# HARNETT CENTRAL PRESS BOX

HARNETT CENTRAL PRESS BOX  
HARNETT COUNTY SCHOOLS  
2911 HARNETT CENTRAL RD, ANGIER, NC 27501

PROJECT INFORMATION:  
DATE: 1/10/2023  
DRAWN BY: RDH  
CHECKED BY: JEL  
SHEET TITLE  
COVER SHEET  
SHEET NUMBER  
G-001  
PROJECT# 21-11110

PLAN NORTH ACTUAL NORTH

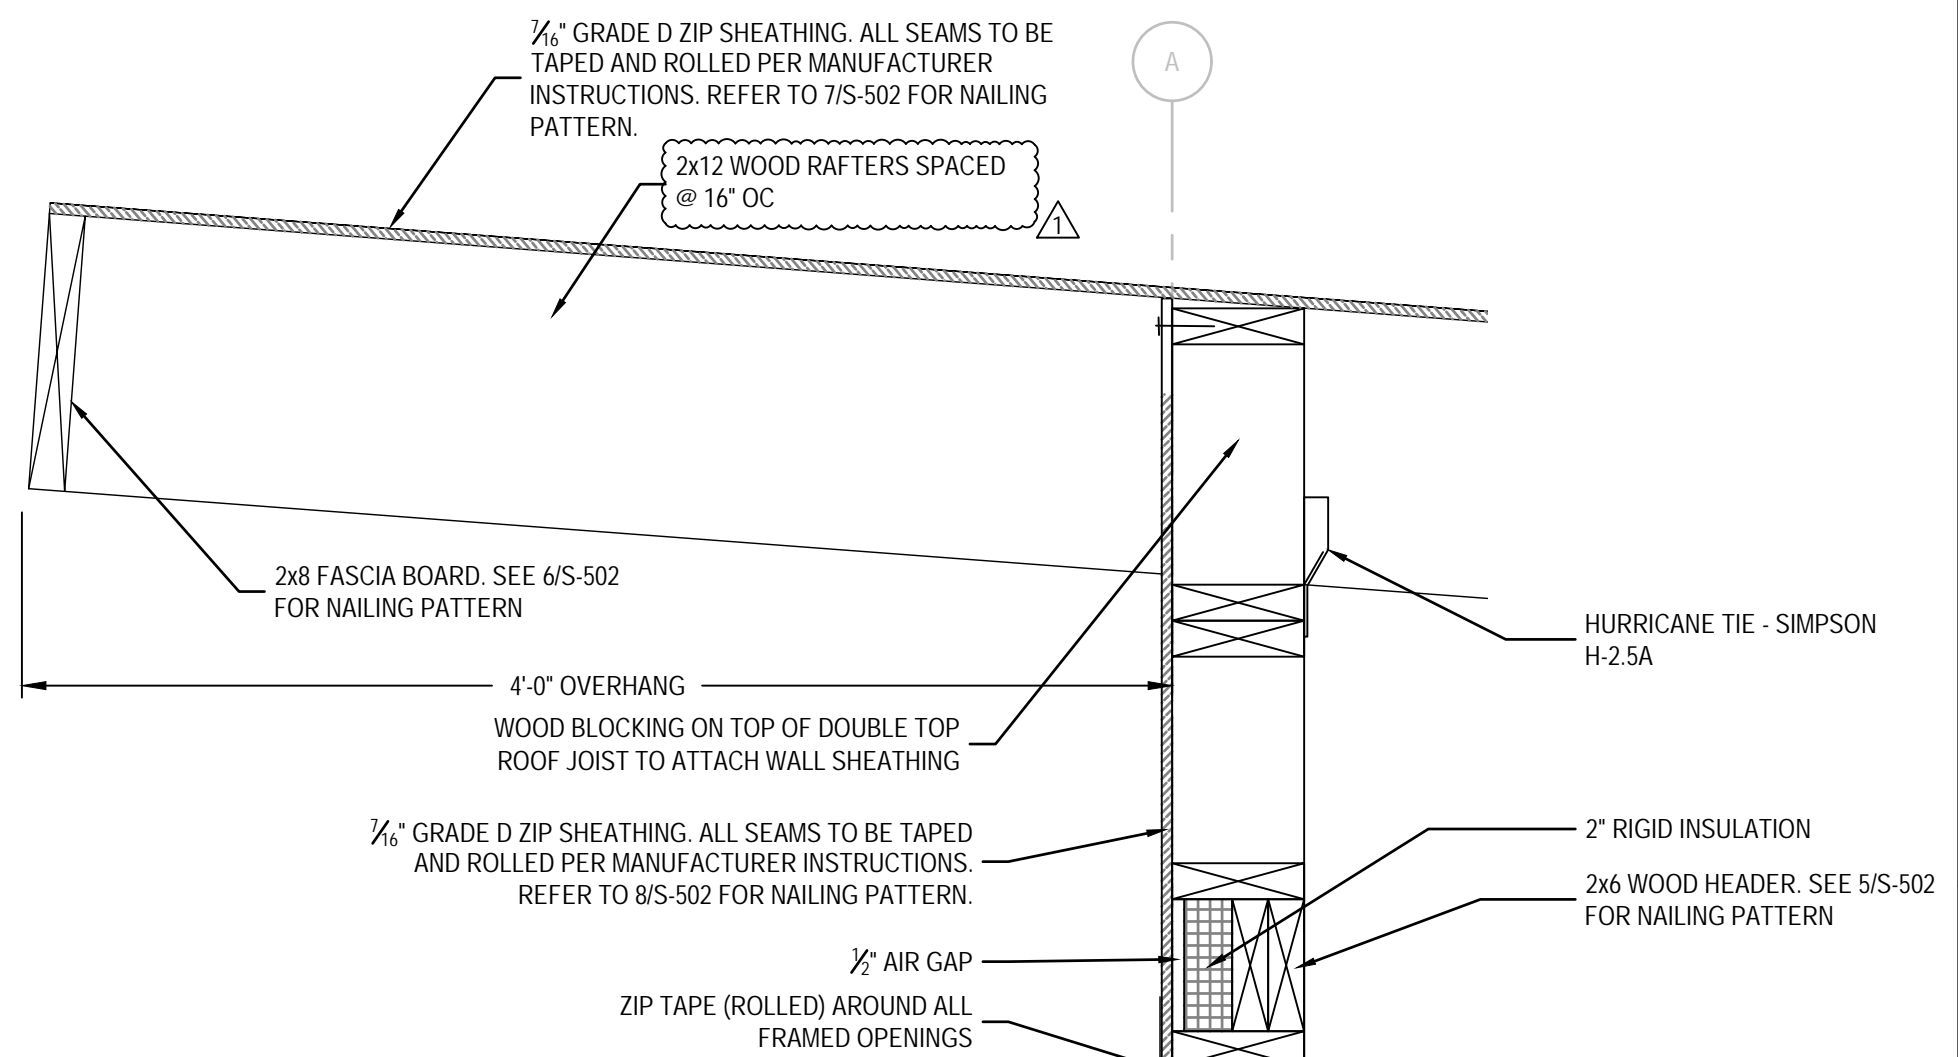
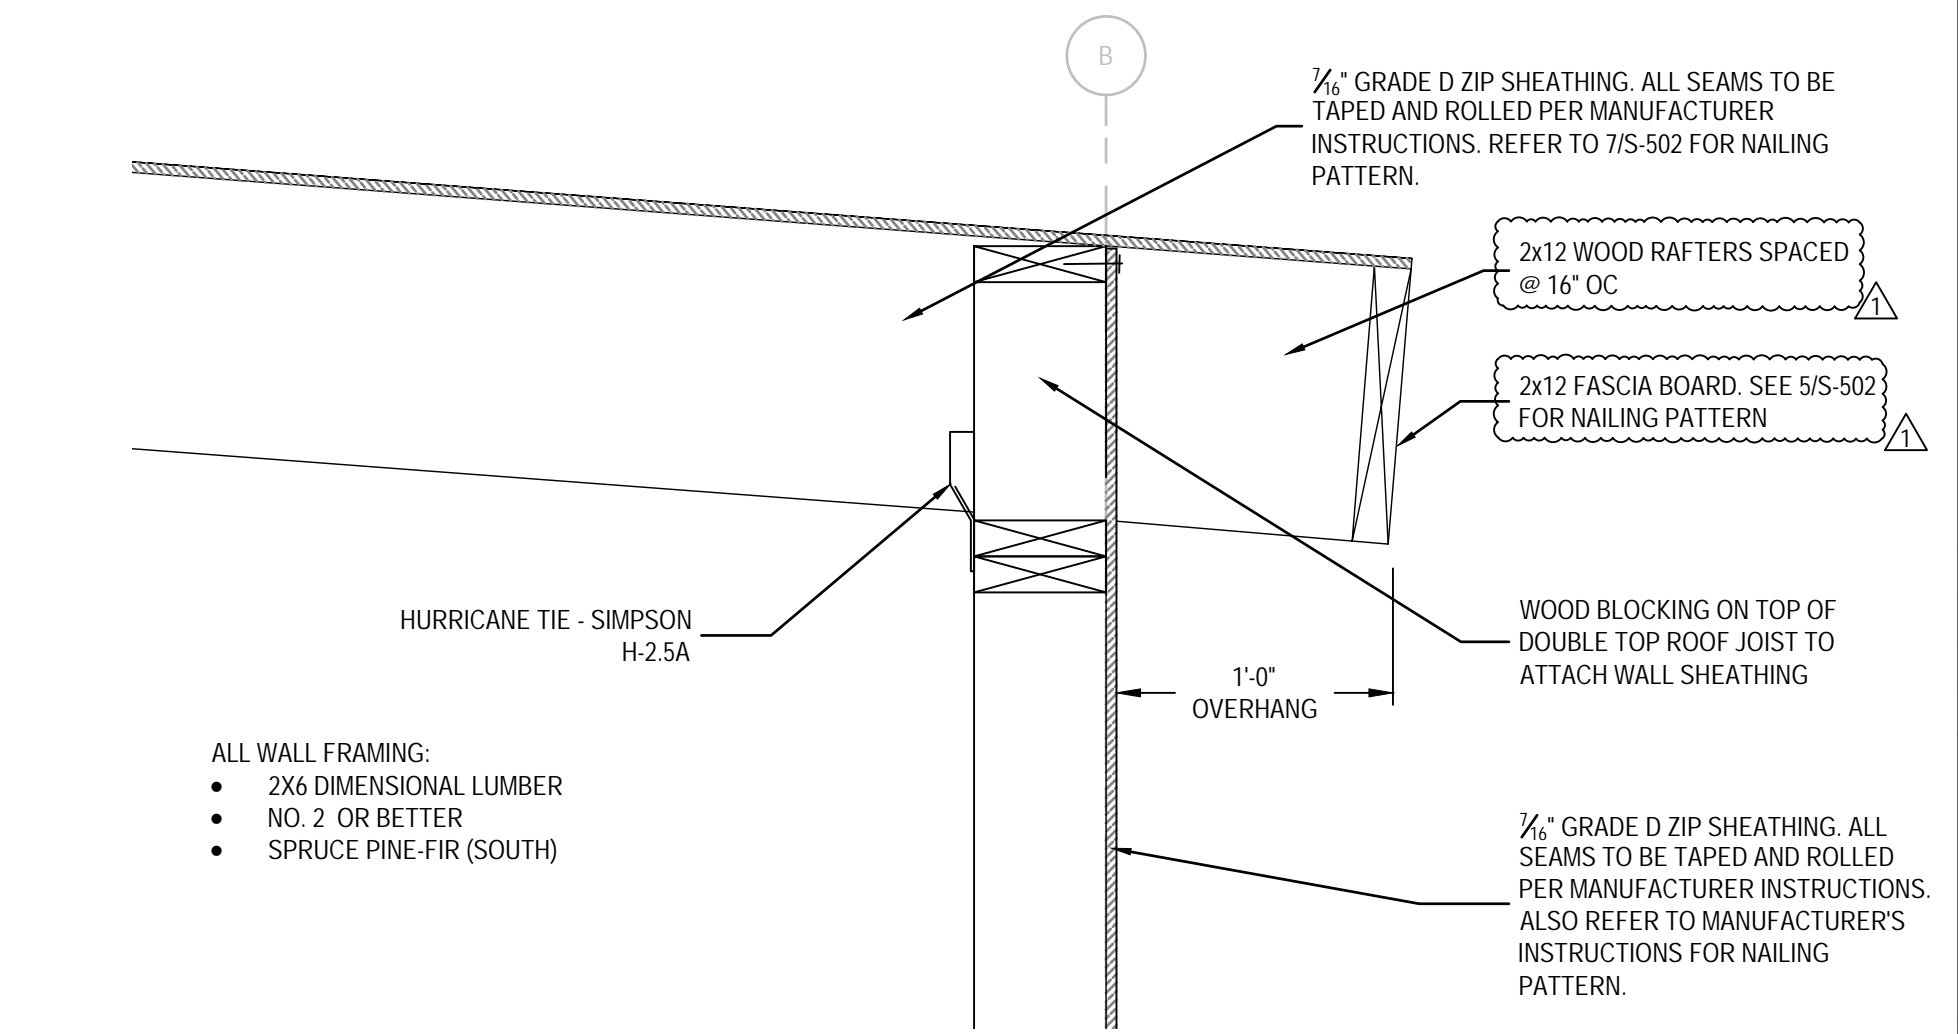
REVISION	DATE	DESCRIPTION
1	4/13/2023	ROOF RAFTERS AND INSULATION CHANGED
2		
3		
4		
5

S-502

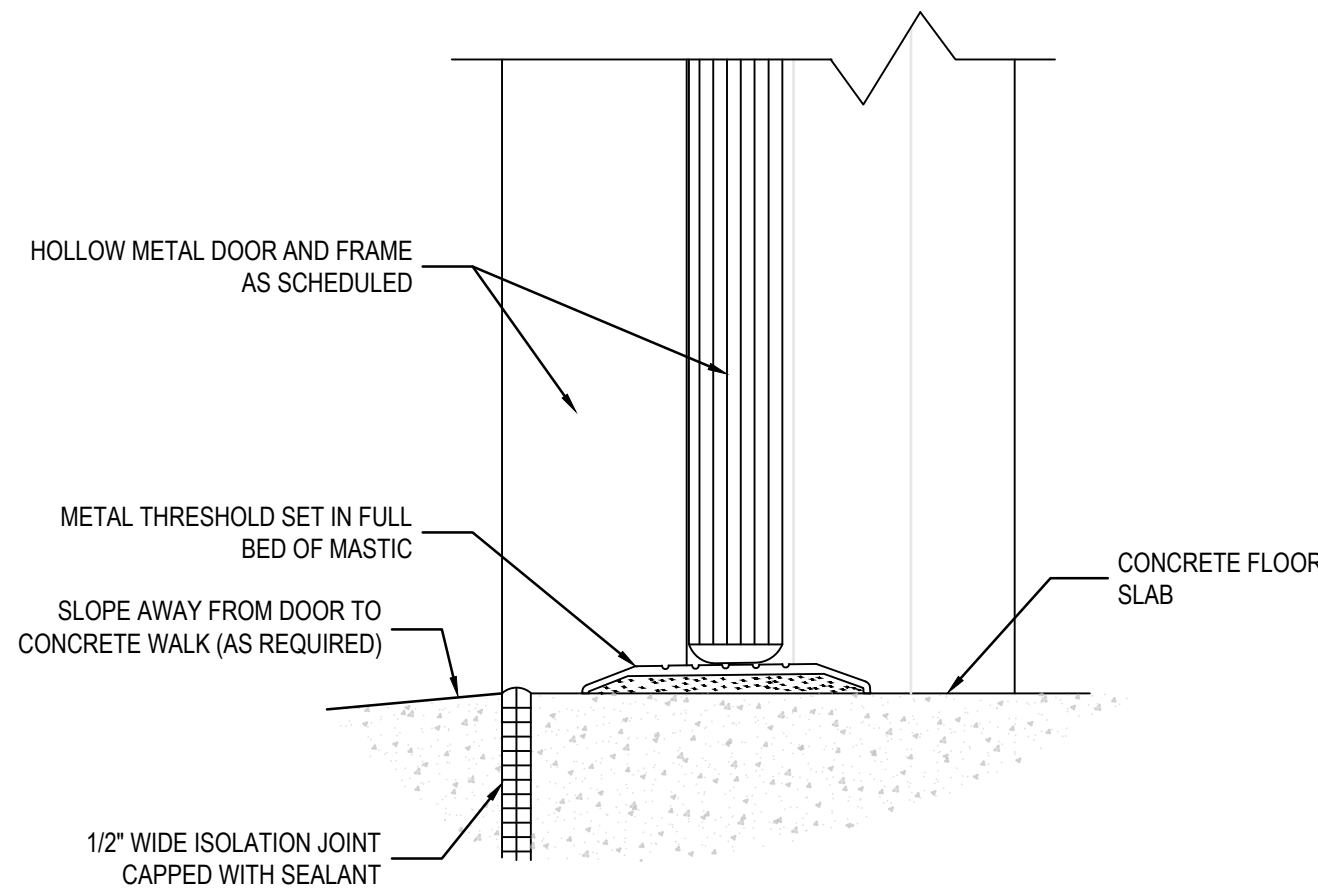
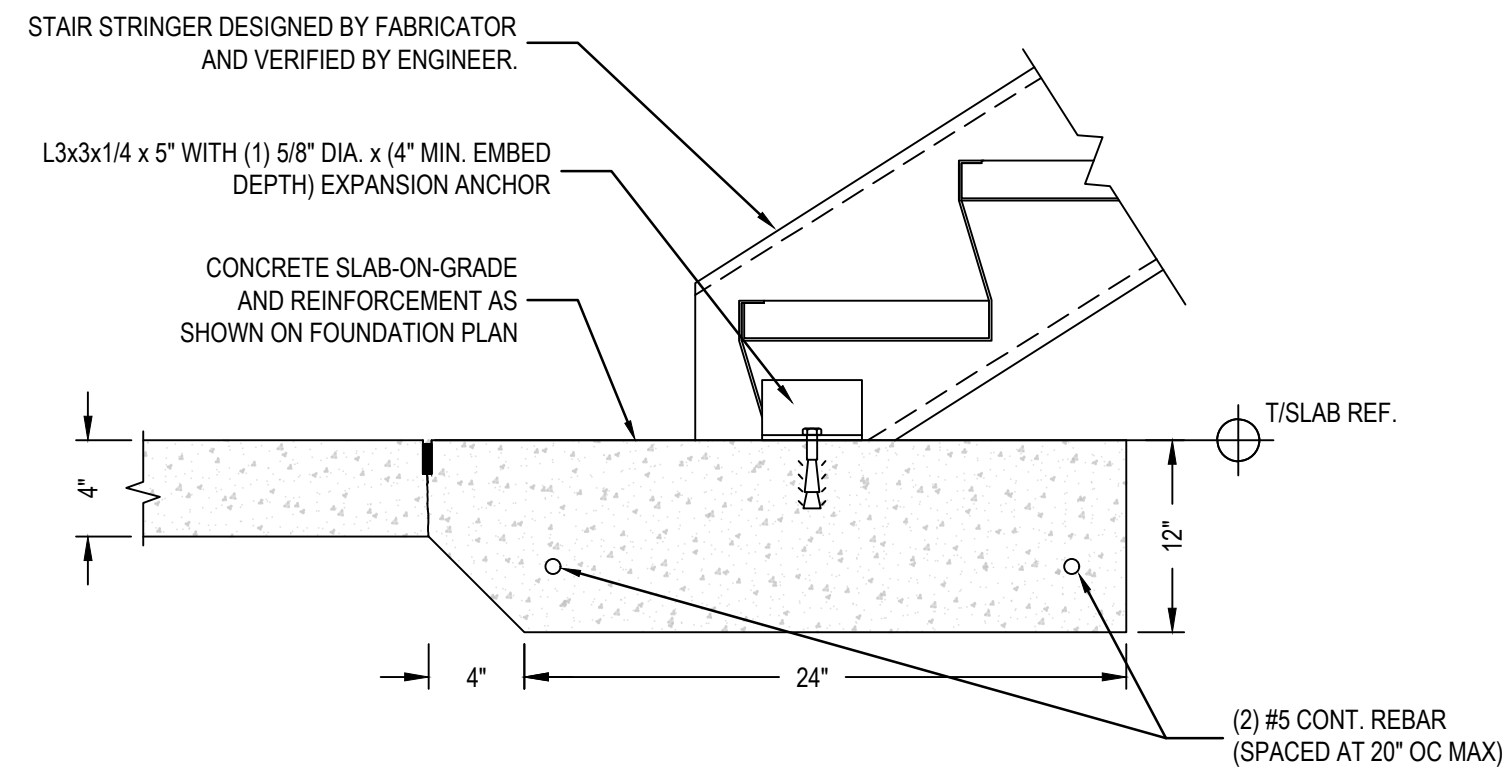
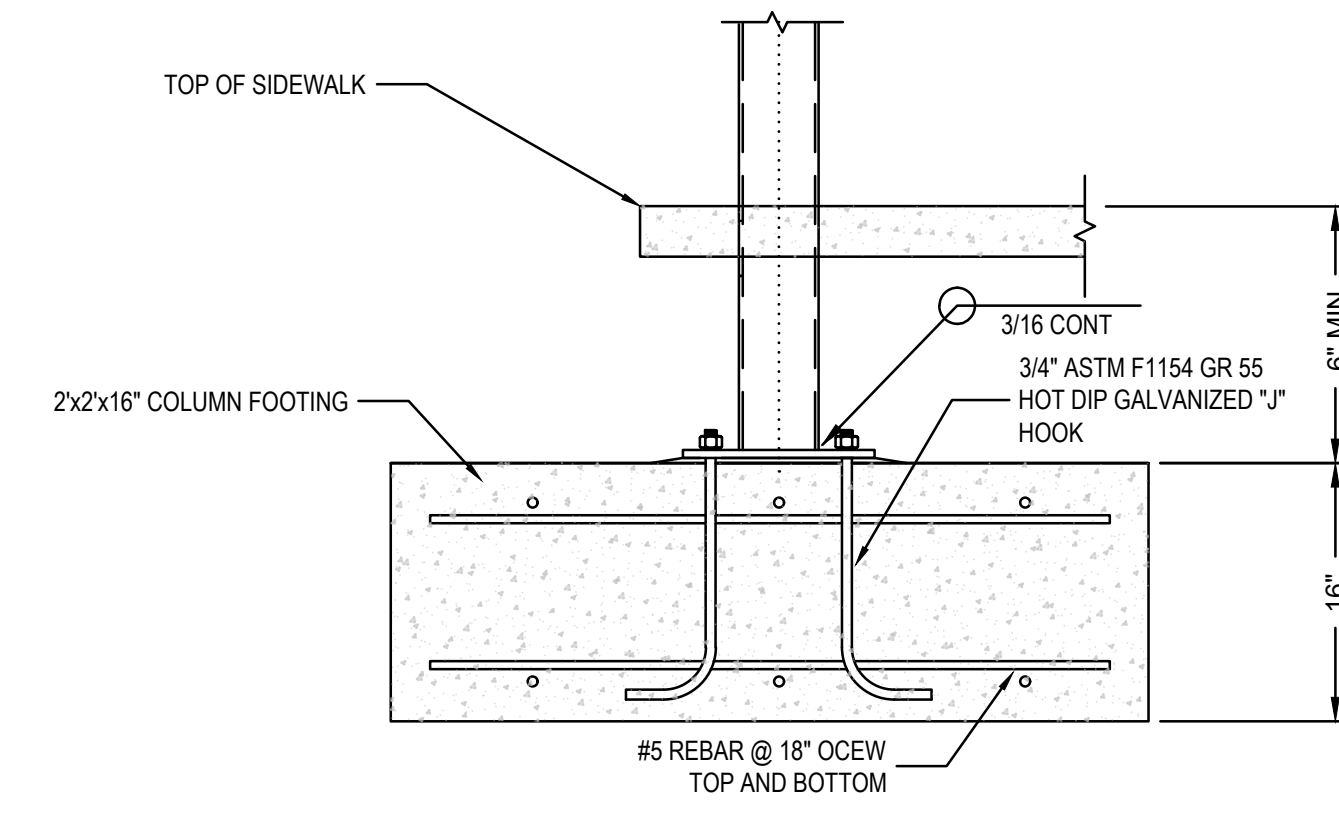
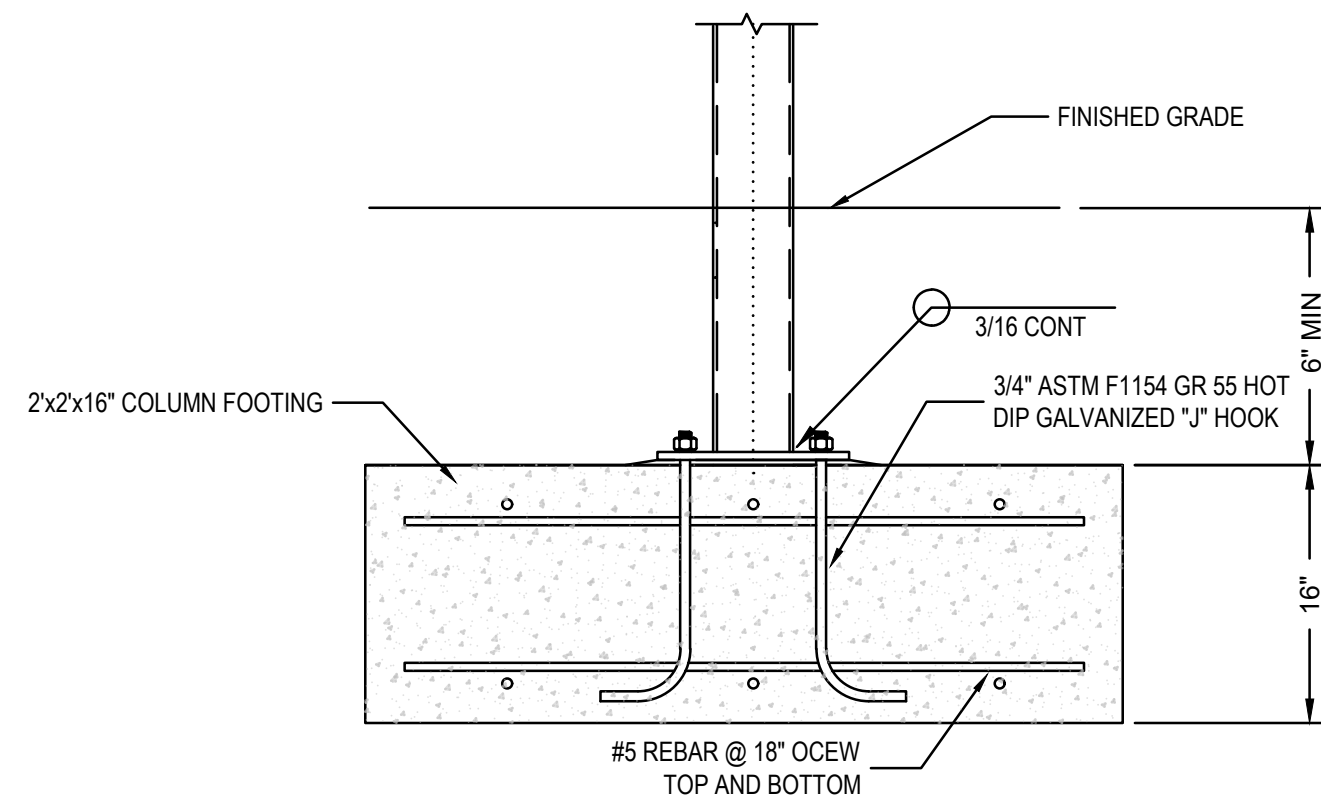
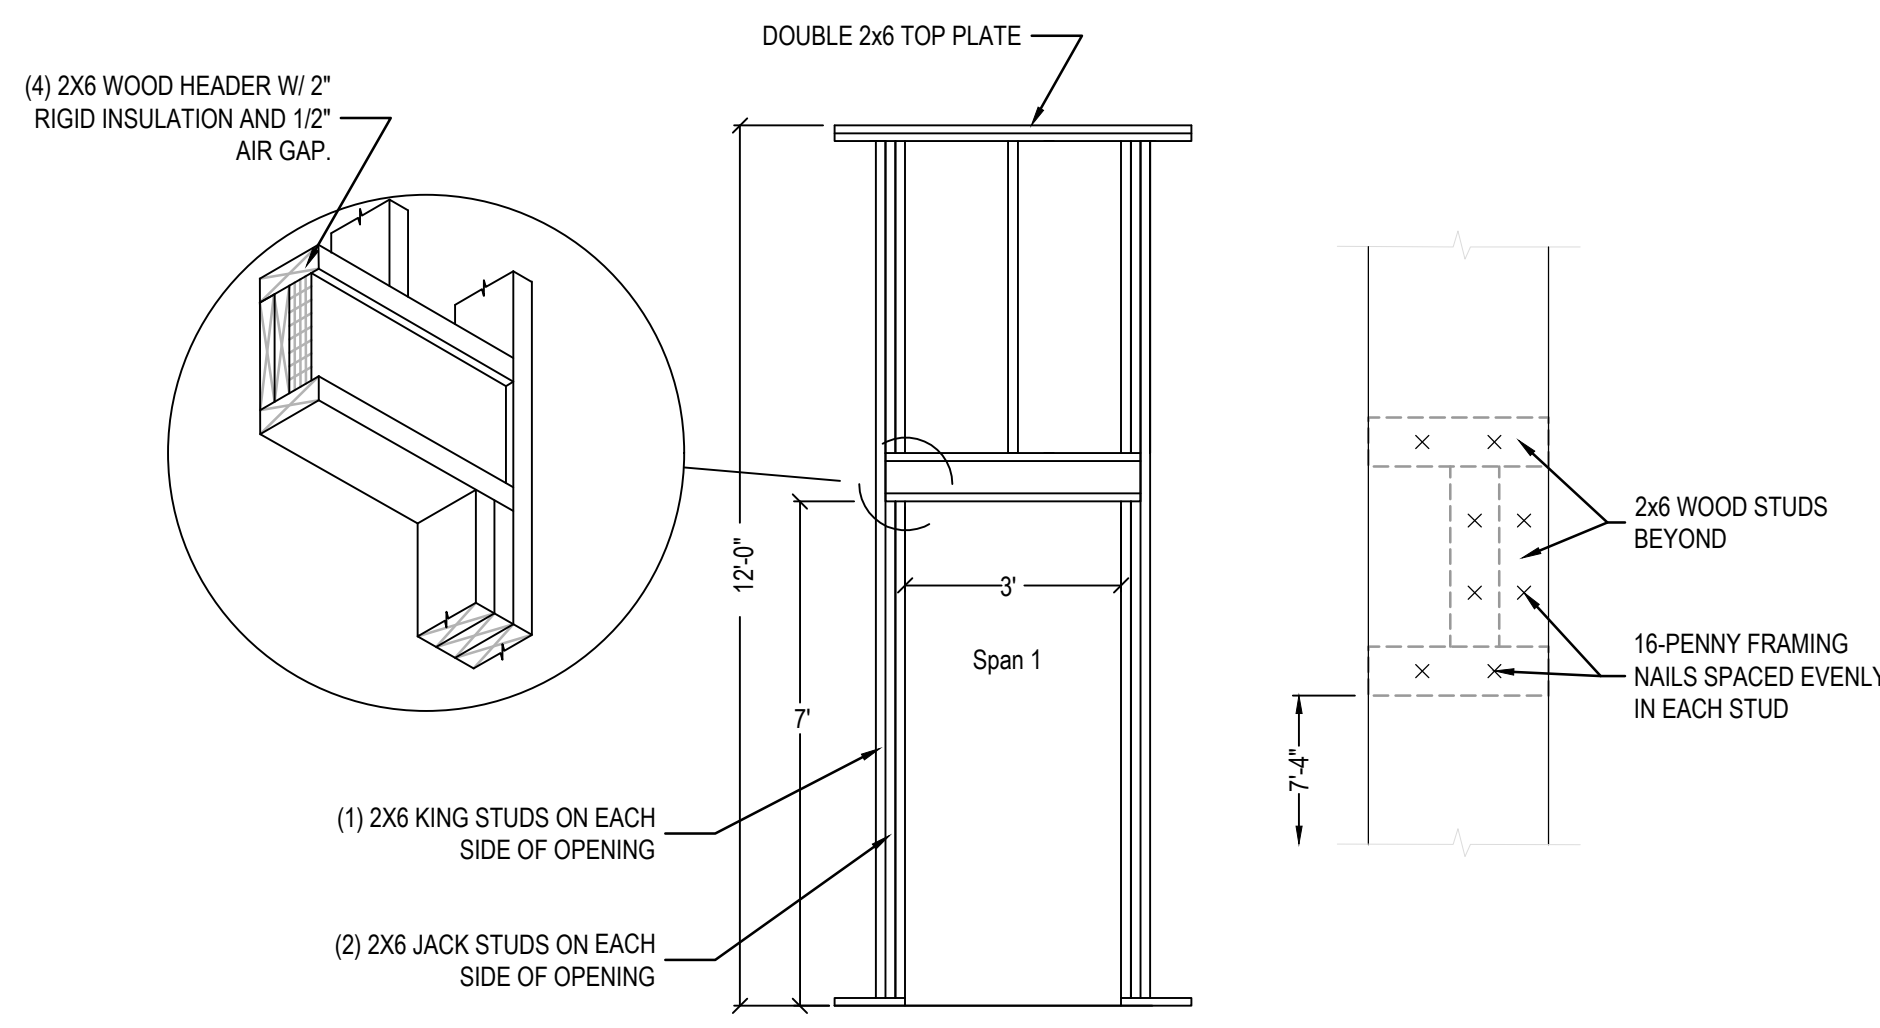
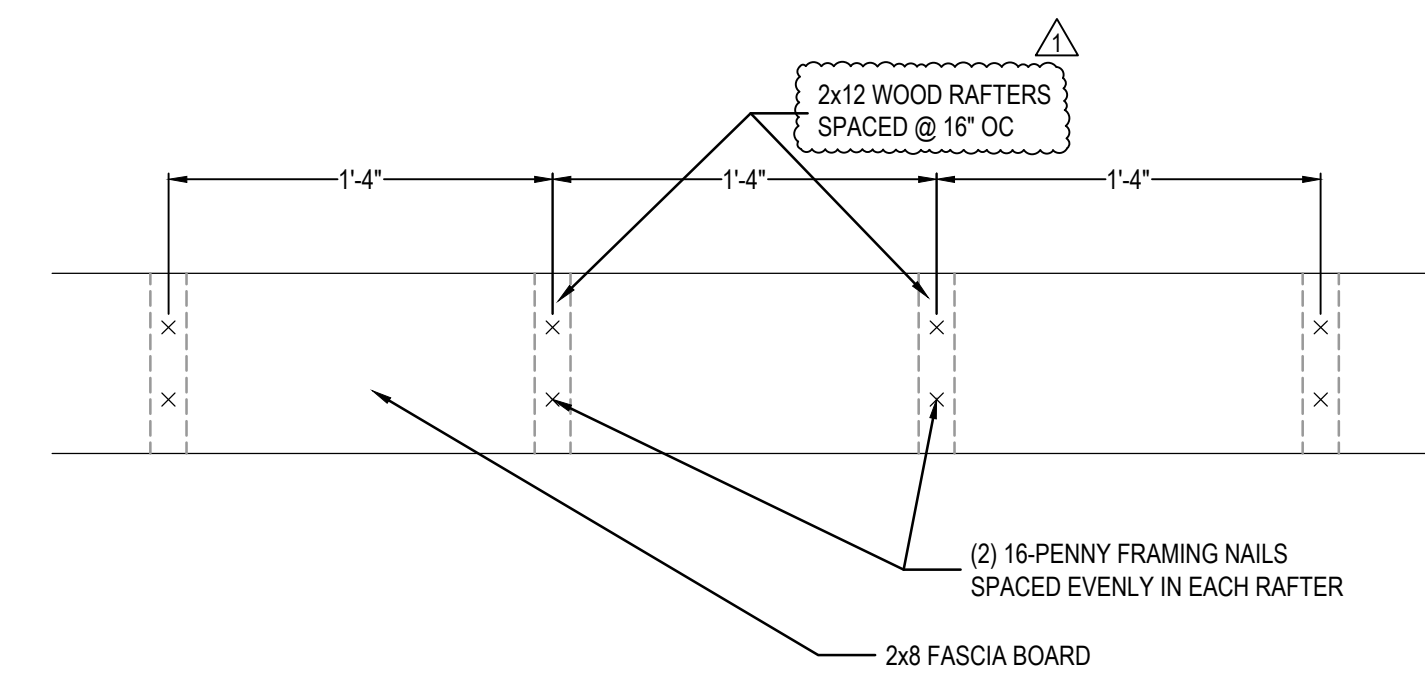
REVISION	DATE	DESCRIPTION
1	4/12/2023	ROOF RAFTERS CHANGED, FLOOR JOIST SIZE CORRECTED.
2		
3		
4		
5
